LAUREATE PARK PHASE 5 PLAT

Applicant's Request: Request for Major Subdivision Plat to create the preliminary plat for Laureate Park Phase 5.

Staff's Recommendation: Approval of the request, subject to the conditions in this report.

PRELIMINARY PLAT

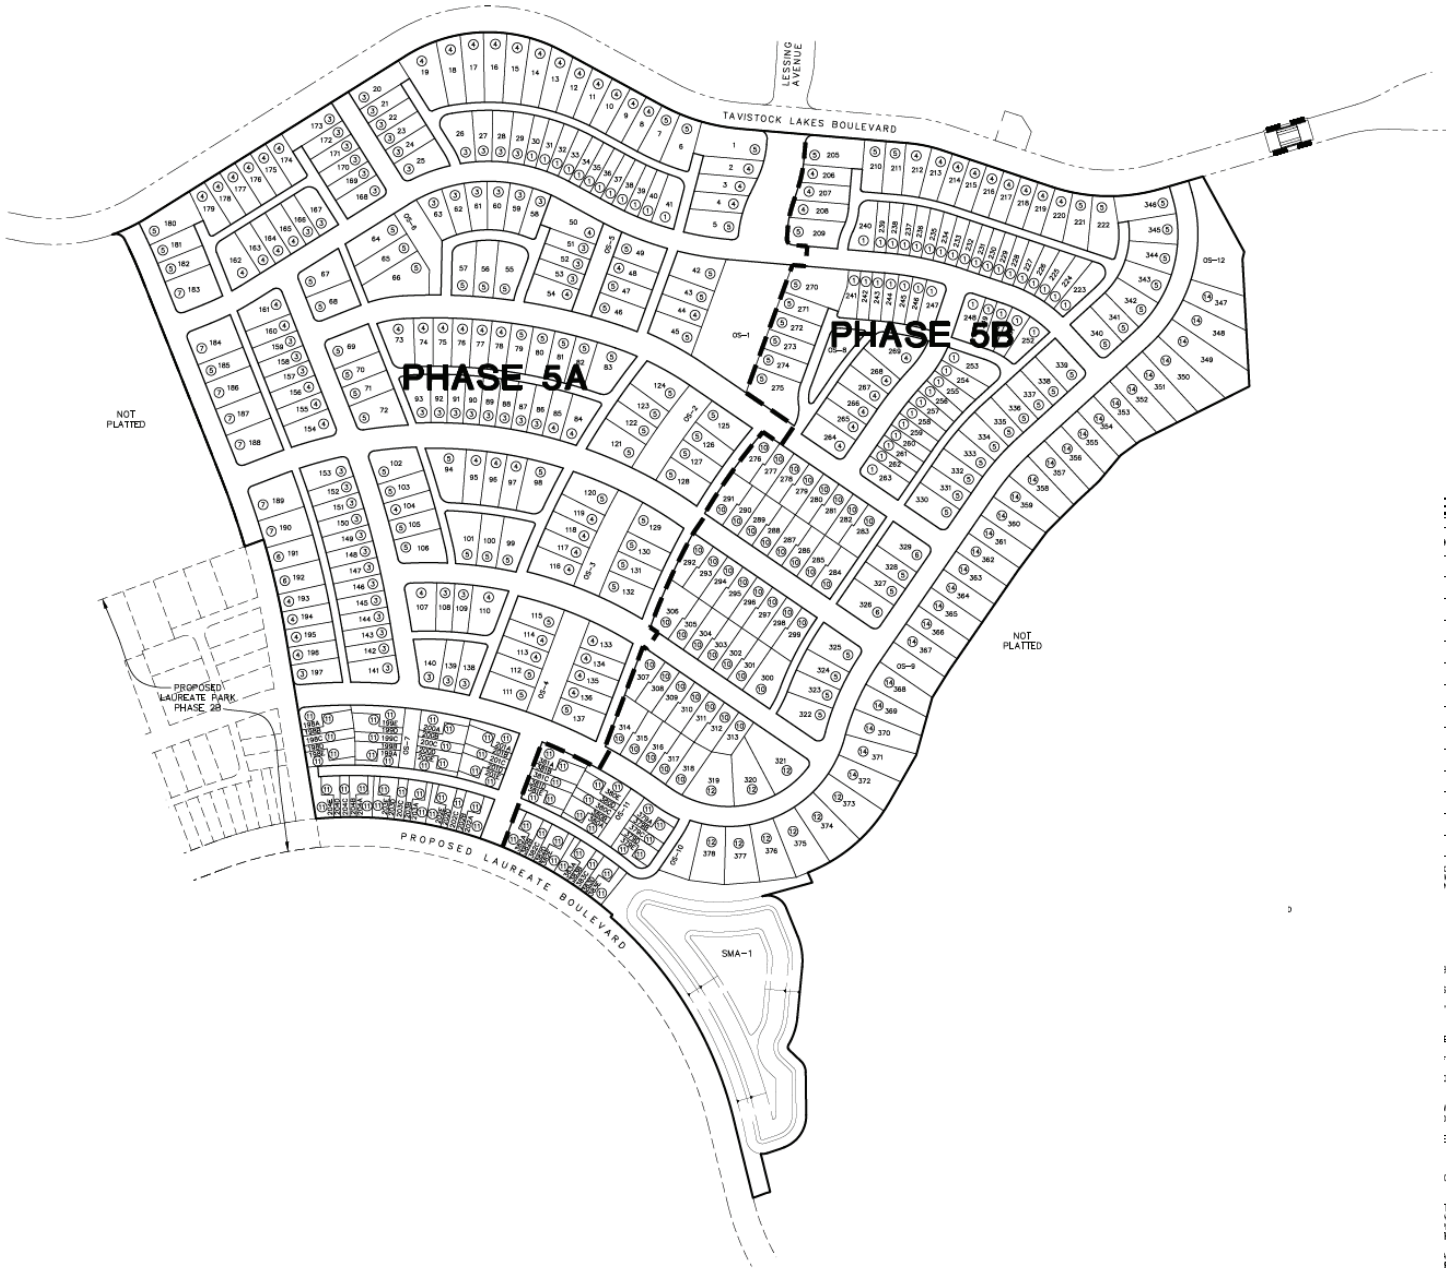
Laureate Park Phase 5 depicts a formal trail along the east side of the development adjacent to the Primary Conservation Network, which is consistent with the Lake Nona Southern Circulation Plan (MPL2011-00004). The preliminary plat does not depict this proposed trail, therefore, the final plat shall depict the 10 foot wide trail on the east side of the development from Tavistock Lakes Boulevard to Laureate Boulevard.

The Laureate Park Phase 5 SPMP addresses a trail network on the east side of the development. The preliminary plat does not depict this proposed trail, therefore, the applicant shall provide a recorded trail easement document that will allow for public access prior to the recording of the Laureate Park Phase 5B plat.

PRELIMINARY PLAT—AERIAL VIEW

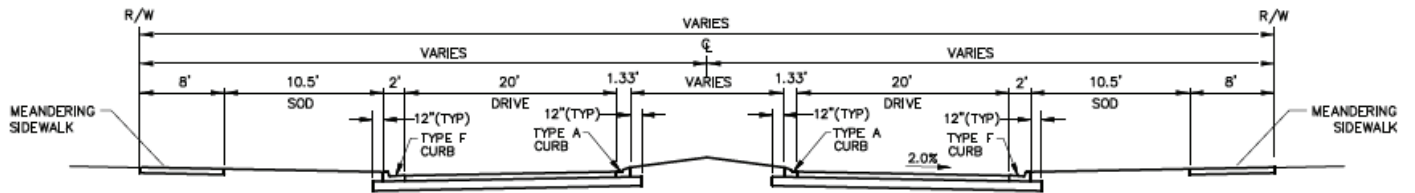
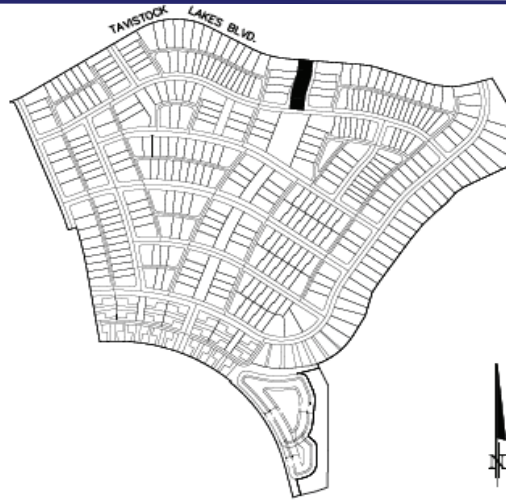
The above graphic is an overlay of the proposed plat on an aerial photo. The southern portion of the plat and the proposed Laureate Boulevard encroach into the current Primary Conservation Network to the south. After discussion with the applicant regarding this matter, it was stated that they have and are continuing to work with the South Florida Water Management District (SFWMD).

Prior to the recording of the final plat, the applicant must show evidence from the appropriate permitting agency (i.e. Army Corps and/or SFWMD) that Laureate Boulevard and adjacent lots are permitted to encroach into the current Primary Conservation Network (PCN), and that amendments to the PCN boundary have been approved to exclude this property. The applicant shall also revise the aerial/plat overlay map to demonstrate the configuration of the road and lots do not encroach into the new PCN boundary.
